Advisory Action Before the Filing of an Appeal Brief

U.S. Patent Application 10/663,259 filed September 16, 2003; Norman S. Martucci, entitled "Method of Making Coated Braided Hose Assembly"; Attorney docket: 79287.21520

FIG. 1

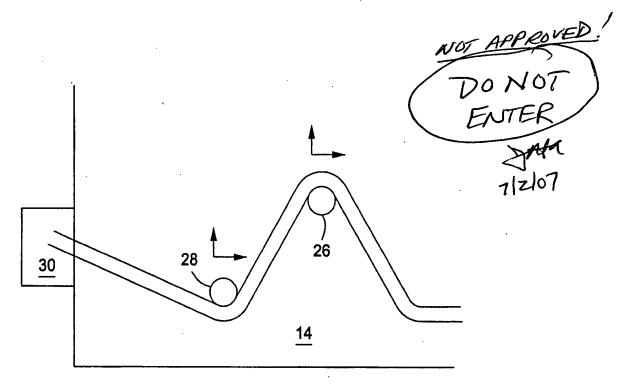
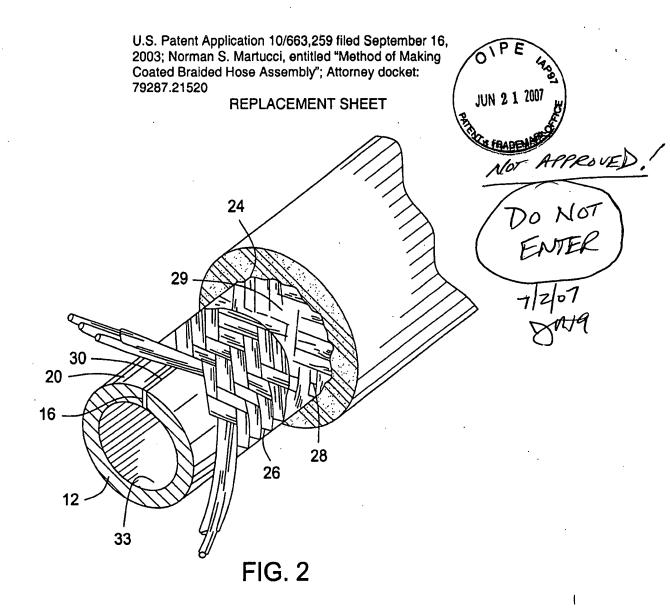
Continuation of 3. NOTE: Initially, it should be ntoed that the drawing changes (replacement sheets) have not been entered as Figure 1 of the replacement sheet does not include a bending devoie identified as 24 in Figure 1 of the original figures. Additionally, Figure 2 includes reference numerals 26, 28 which are identified as beinding devices in Figure 1 and should be renumbered and reference to the same changed in the specification where appropriate. With regard to the proposed claims, it should be noted that the claims all require that the bending objects be "rotatable wheels". While the original disclosure did describe the bending objects as "wheels" it is not clear whether the original disclosure recited that these objects (wheels) were "rotatable". This raises a new issue regarding support in the original disclosure (i.e. whether applicant was in possession of the claimed invention under 35 USC 112, 1st paragraph). Additionally, limiting the bending devices to rotatable wheels creates a new issue which requires additional search and/or consideration. It should also be noted that amending the claim in the fashion proposed raises some concerns regarding how claim 17 further defines claim 13 as claim 13 already has presetned the reservoir for the polymeric material.
